Technical Bulletin 1.0 – v2 (23 February 2024)

Non-compliant Sumps / Sump & Rainhead combinations

Re: Non-compliant Sumps / Sump & Rainhead combinations

Photograph 9 – Type B overflow

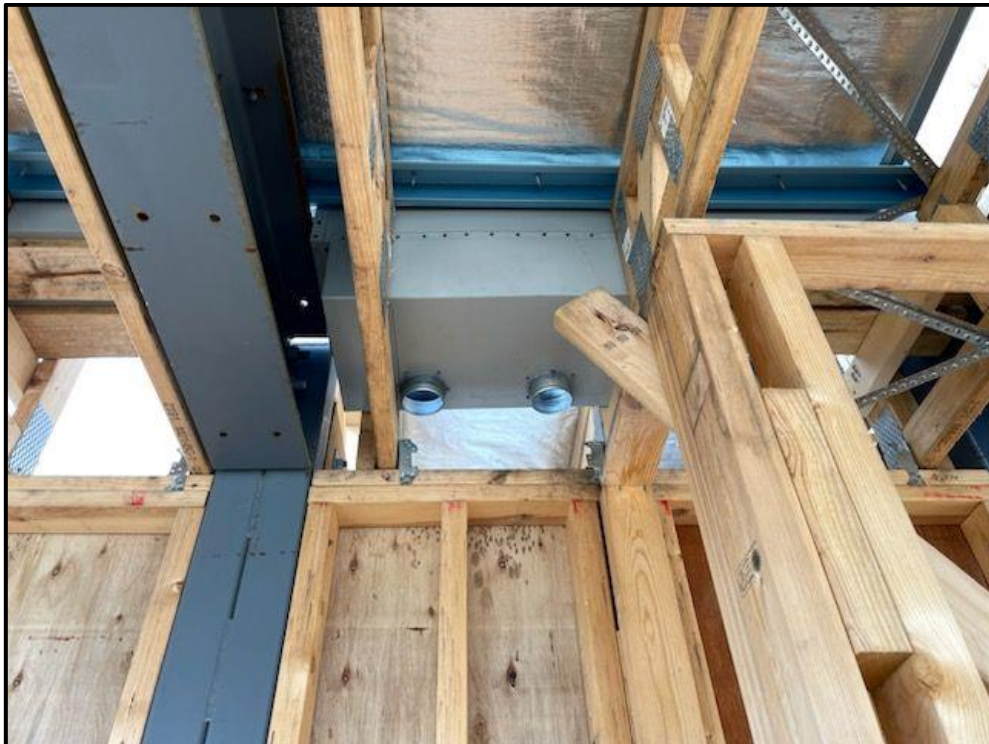
- This arrangement appears to effectively be a Sump/ Side Outlet, with the overflow penetrating the external wall, and discharging over a rainhead (not yet installed in the example provided).

- The overflow duct cannot discharge over a rainhead (as noted above). The reason for this is that there could be a blockage in the sump DP (which is assumed to connect into through the rainhead downpipe) between the sump and the rainhead downpipe. This blockage would typically go undetected if the rainhead and its downpipe were operating normally and the overflow was only discharging small amounts of water over the rainhead, and hence prevent an alert to carry out proper maintenance of the box gutter system. Then, when a high intensity event occurred, the overflow may itself block or partially block and not be able to cope, causing flooding of the building.

- Further to the above, even if discharge of the overflow duct into or over the rainhead were acceptable as a DtS Solution, the rainhead would need to be an ‘Open Fronted’ rainhead as depicted in the Normative Figures in 3500.3 in order to have compliant overflow provision itself, as no other rainhead design is shown or described with AS3500.3. This has not changed since at least the 1998 version.

BOX GUTTER DETAIL 1 - 1:20

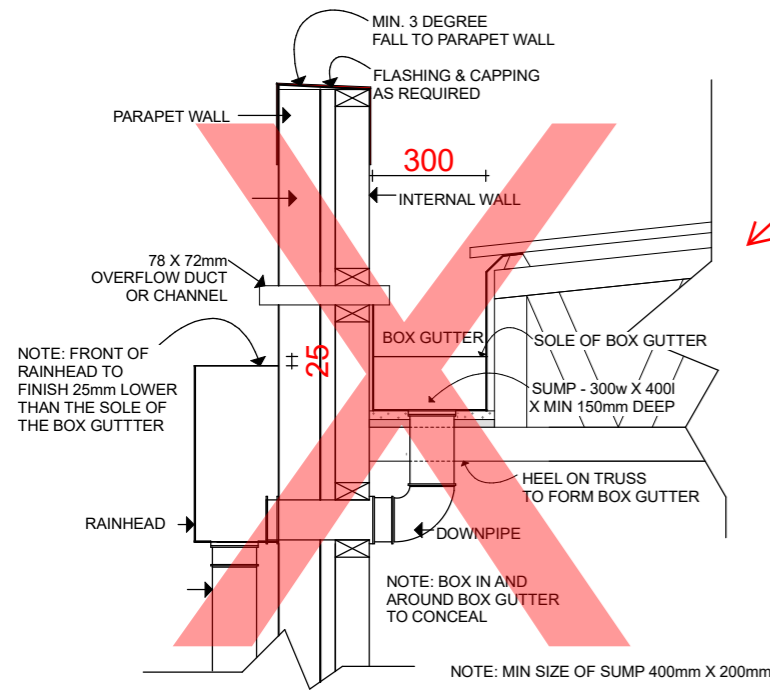
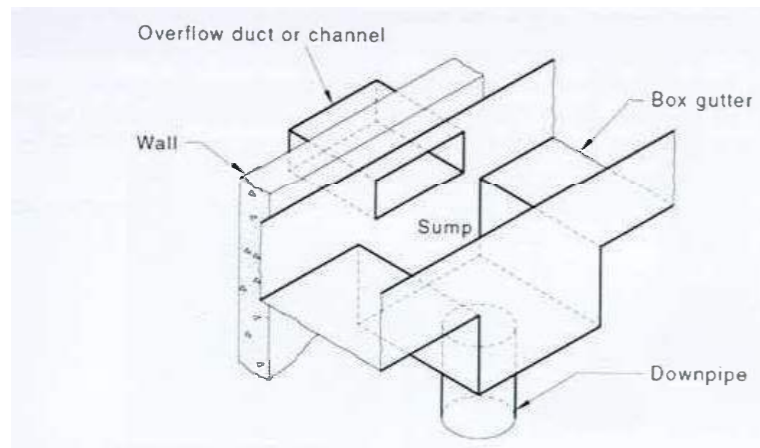
This detail is non-compliant* because:

- 1) It is not sized correctly as a Sump / Side Overflow to AS/NZS 3500.3 (overflow duct is too small)
- 2) The overflow cannot discharge into the rainhead, it must discharge to the surface drainage system as per AS/NZS 3500.3. Note, if a blockage occurs in the pipe between the RH and the sump, this may not be detected.
- 3) Note, even if it were permissible for the overflow duct to discharge into the rainhead, then the rainhead would have to comply with AS/NZS 3500.3 and be an 'open fronted' rainhead.

BOX GUTTER DETAIL 2 - 1:20

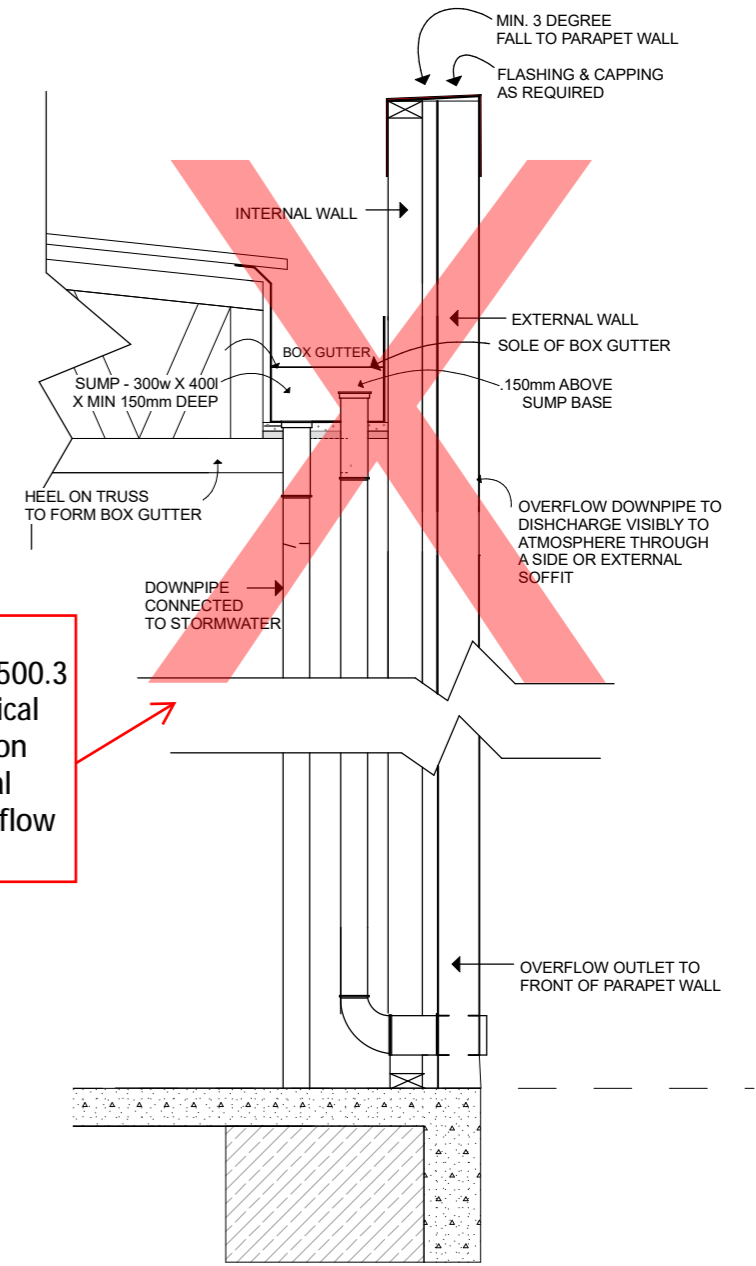
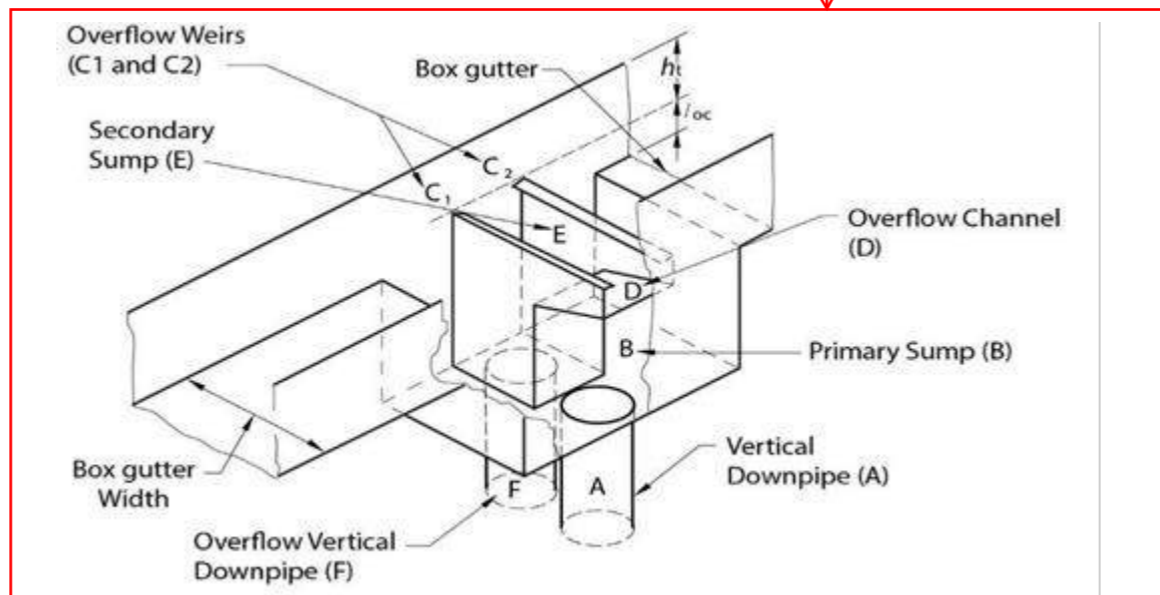
This detail is non-compliant* because:

- 1) It is not a Sump / High capacity overflow device per AS/NZS 3500.3
- 2) There is no method provided in AS/NZS 3500.3 to design vertical piped overflows. The hydraulic capacity of the pipe depends on the size of the pipe and head of water over it. Clearly a vertical piped overflow has much less hydraulic capacity than the overflow pipe in a Sump / High Capacity overflow device.
